COUNCIL ACTION FORM

SUBJECT: MAJOR SITE DEVELOPMENT PLAN / PRELIMINARY PLAT FOR SOMERSET SUBDIVISION, 24TH ADDITION

LAYOUT PLAN

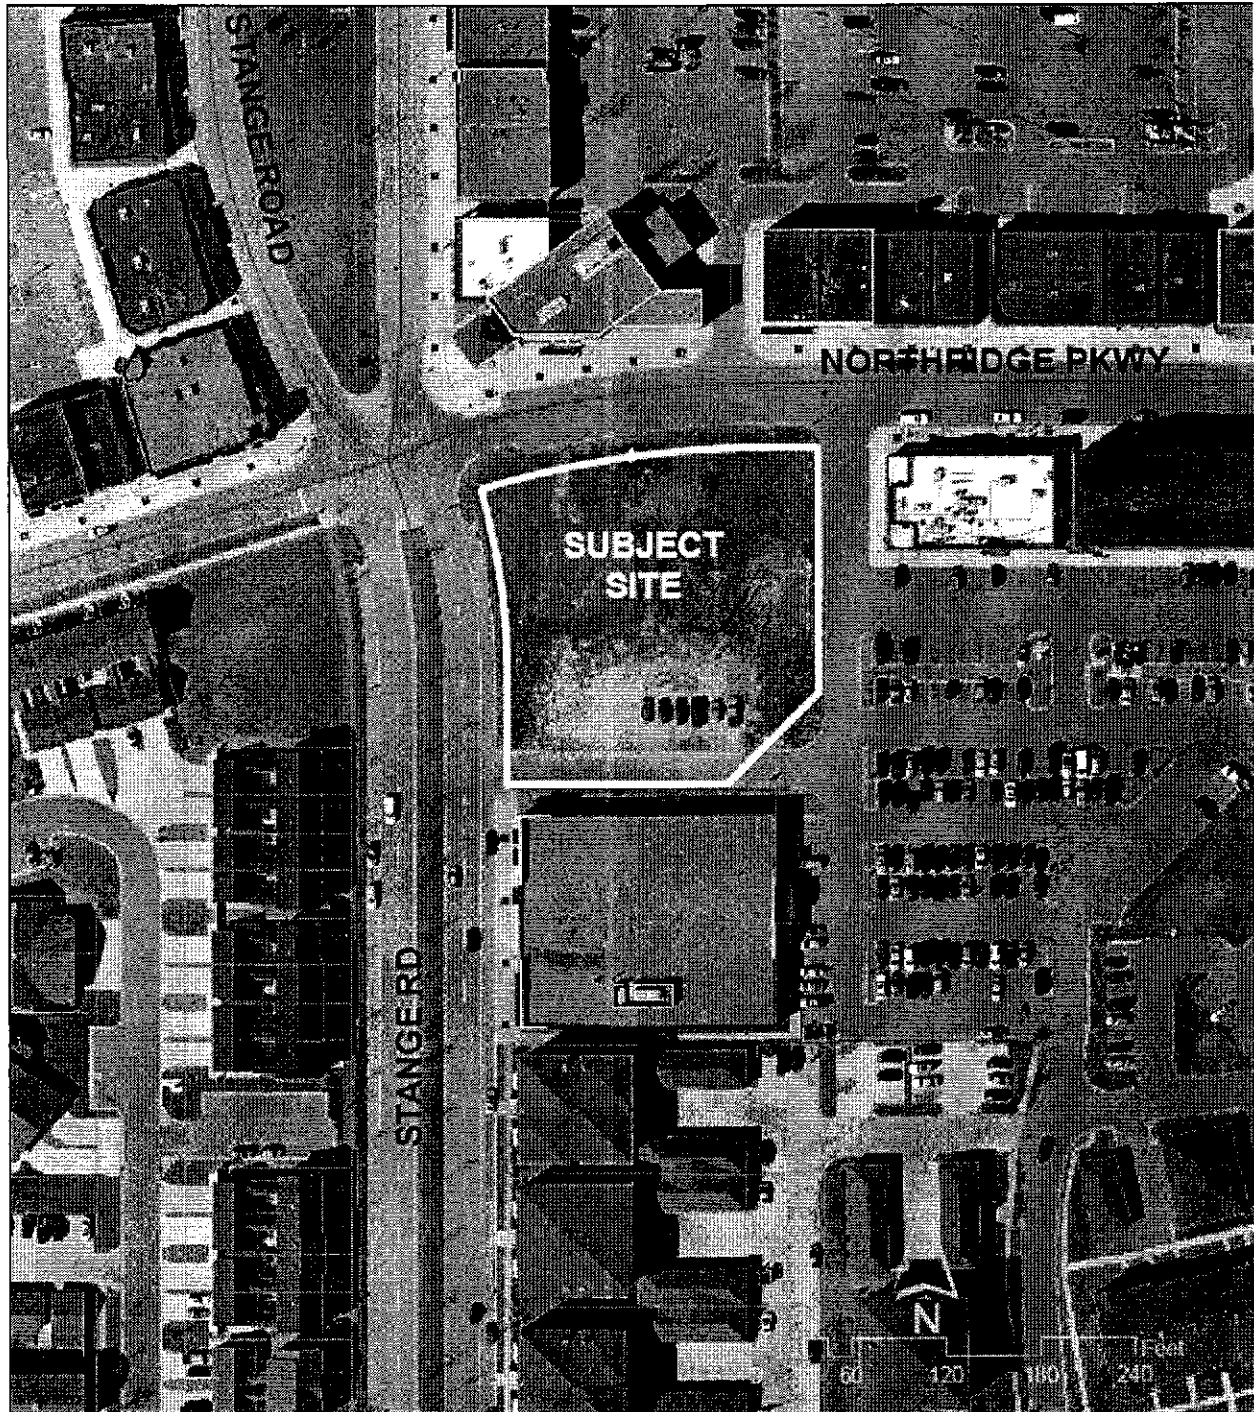
- 2) *Section 29.408(3) Garbage Collection Areas:* This section describes the screening requirements for dumpsters. The proposed location of the dumpster within the parking lot is acceptable but needs to be screened to the F2 standard (6 feet high and 100 percent sight obscuring). While the location of the dumpster is shown, there is no indication of its height, materials, or whether there is a gate. Staff conditions its recommendation for approval on the applicant submitting information demonstrating that the F2 requirement will be met. There is also a contradiction in the materials on which the dumpster is placed. Sheet C2.1 identifies the trash pad as PCC (Portland Cement Concrete) while Sheet C5.1 identifies it as river rock mulch. PCC is the preferred material for this location and staff will recommend approval conditioned on the applicant providing clarification.

- a. Prior to final plat approval, the applicant shall submit information demonstrating that the dumpster screening is gated, is six-feet in height, and is of a material that is 100 percent sight obscuring.

- b. Prior to final plat approval, the applicant shall submit the required COSESCO paperwork to the Public Works Department.
 - c. Prior to final plat approval, the Major Site Development Plan shall be corrected to indicate that the proposed dumpster location will be Portland Cement Concrete.

UTILITY PLAN

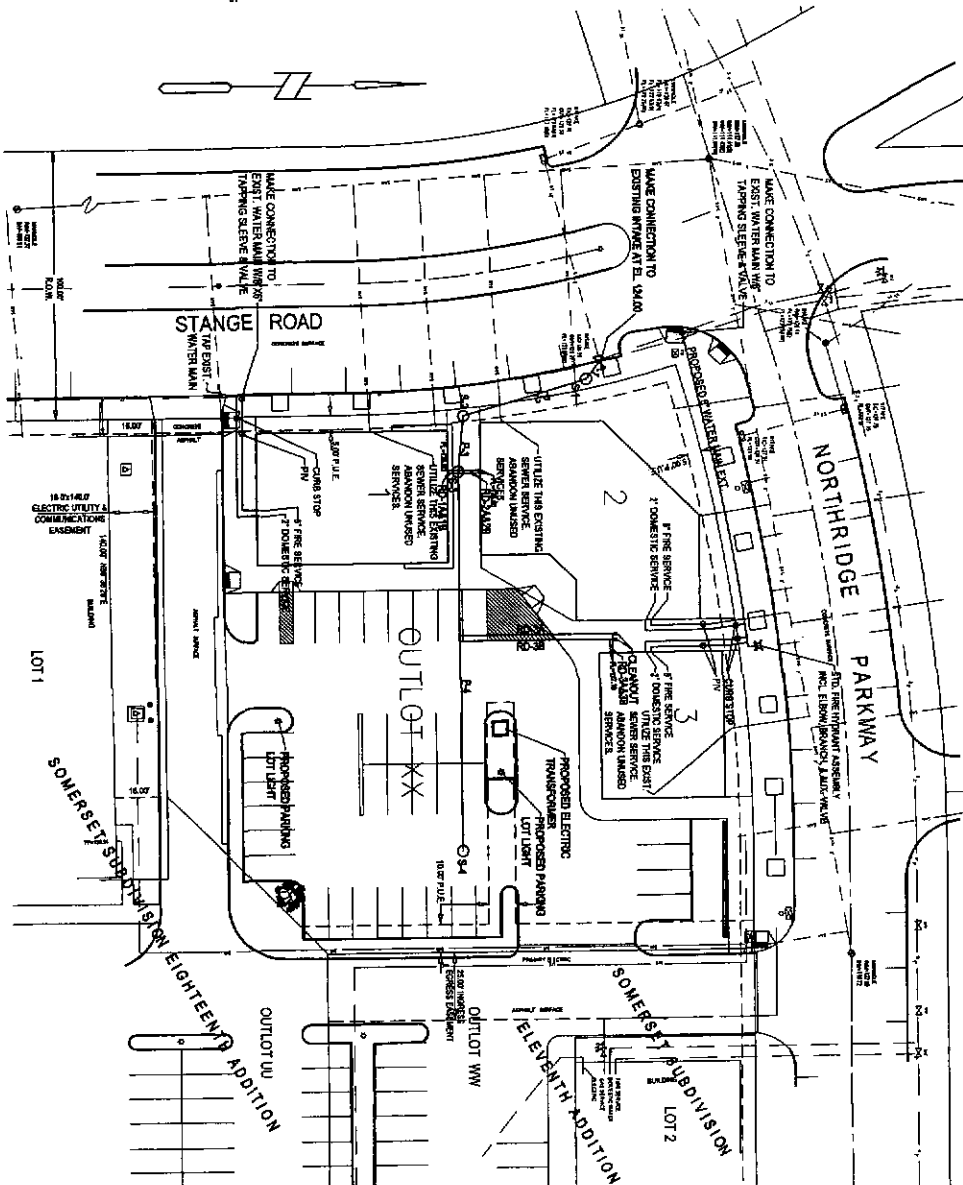
All utilities necessary to accommodate the lots are located either in Stange Road or Northridge Parkway. The proposed utility plan anticipates an extension of the water line to

a new hydrant on Northridge Parkway to accommodate the three commercial lots. Water main connections shall be made at approved locations for domestic and fire service lines to each of the buildings. Sanitary sewer connections shall be made at approved locations and shall utilize existing stub-outs under Stange Road or Northridge Parkway.

Electric lines to serve the proposed utility cabinet in the parking lot and the parking lot lights shall be buried. The locations of the proposed easements are shown and shall be established by final plat approval. Parking lot lighting and poles shall be as provided for in previous Village commercial parking lots.
